AMENDMENT TO FACILITY OPERATING LICENSE

Amendment No. 17  
License No. DPR-74

SAFETY EVALUATION BY THE OFFICE OF NUCLEAR REACTOR REGULATION  
RELATED TO AMENDMENT NO. 17 TO FACILITY OPERATING LICENSE NO. DPR-74

DONALD C. COOK NUCLEAR PLANT UNIT NO. 2

FIGURE 3.2-2 K(Z) - NORMALIZED  $F_0(Z)$  AS A FUNCTION OF CORE HEIGHT

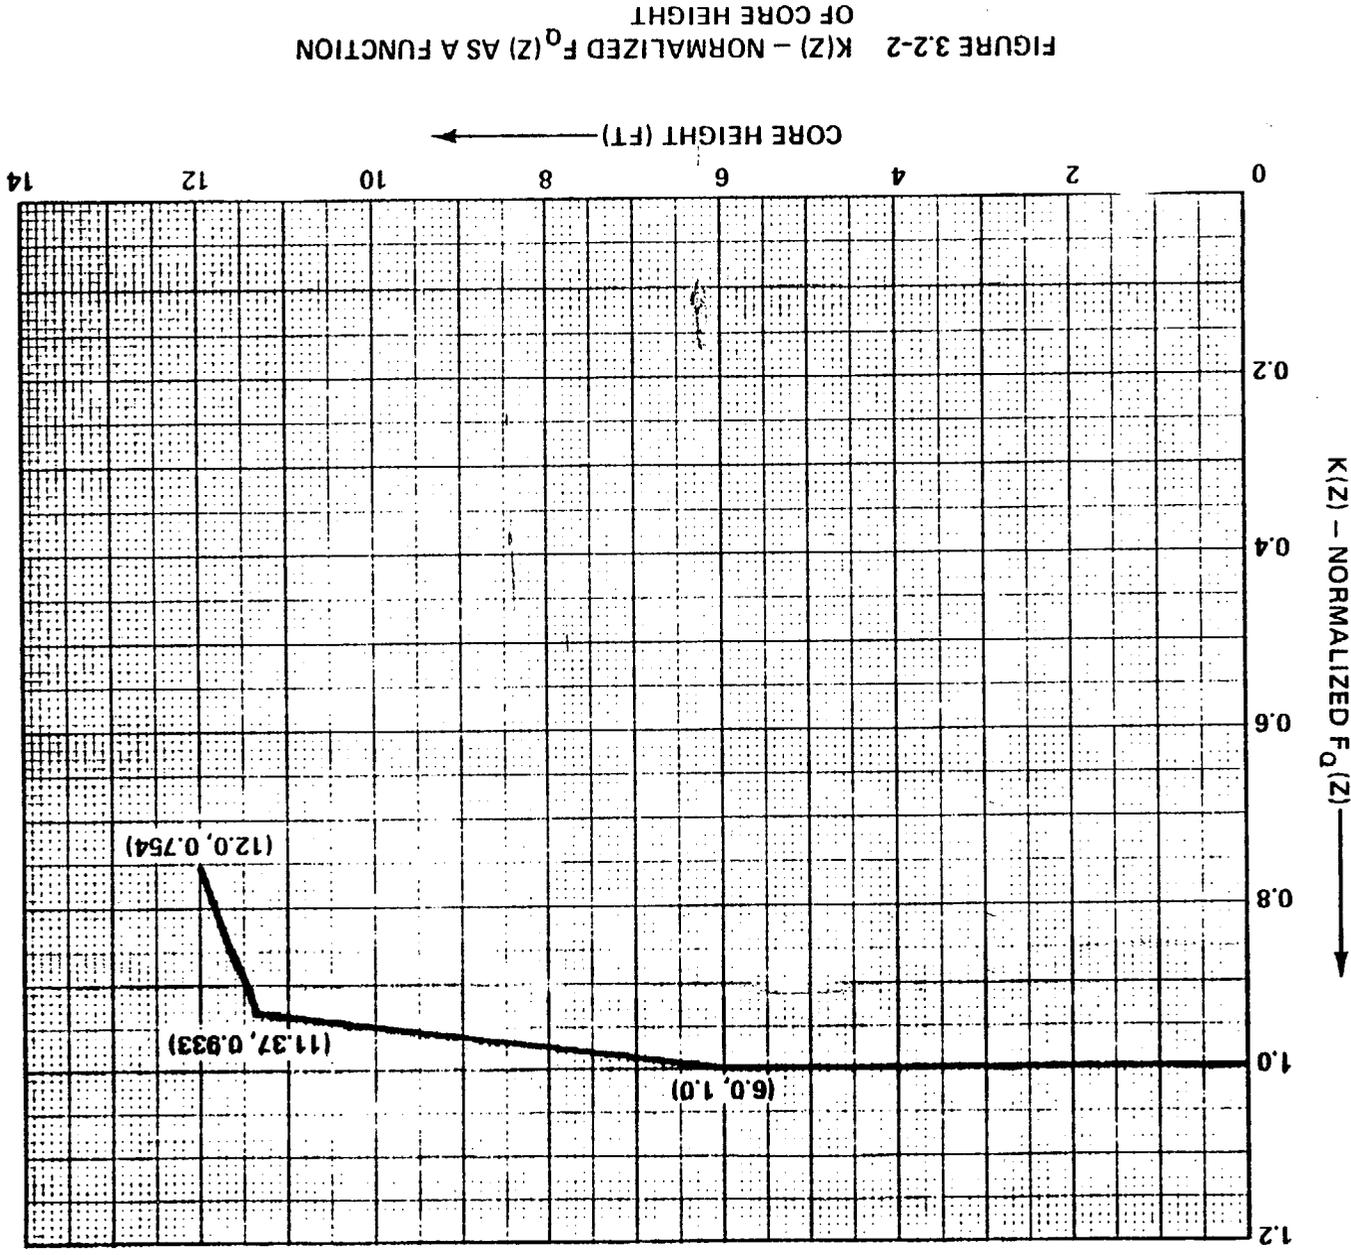
Change No. 1 (Reference 1) Revision to Limiting Condition of Operation (LCO) 3.2.2 Figure 3.2-2 and Basis Item 3/4 2.1.

The change involves lowering the maximum allowable  $F_q(z)$  limits, with the peak value reduced to 1.99. The  $K(z)$  curve is renormalized to the lower  $F_q$ . As discussed in Section 2.0, an  $F_q$  of 1.99 is necessary to meet the requirements of 10 CFR 50.46.

The  $K(z)$  curve shown in Figure 3.2-2 was derived from the small break analysis of record, and the revised large break analysis presented in reference 2. This curve is also consistent with the values used in Reference 9.
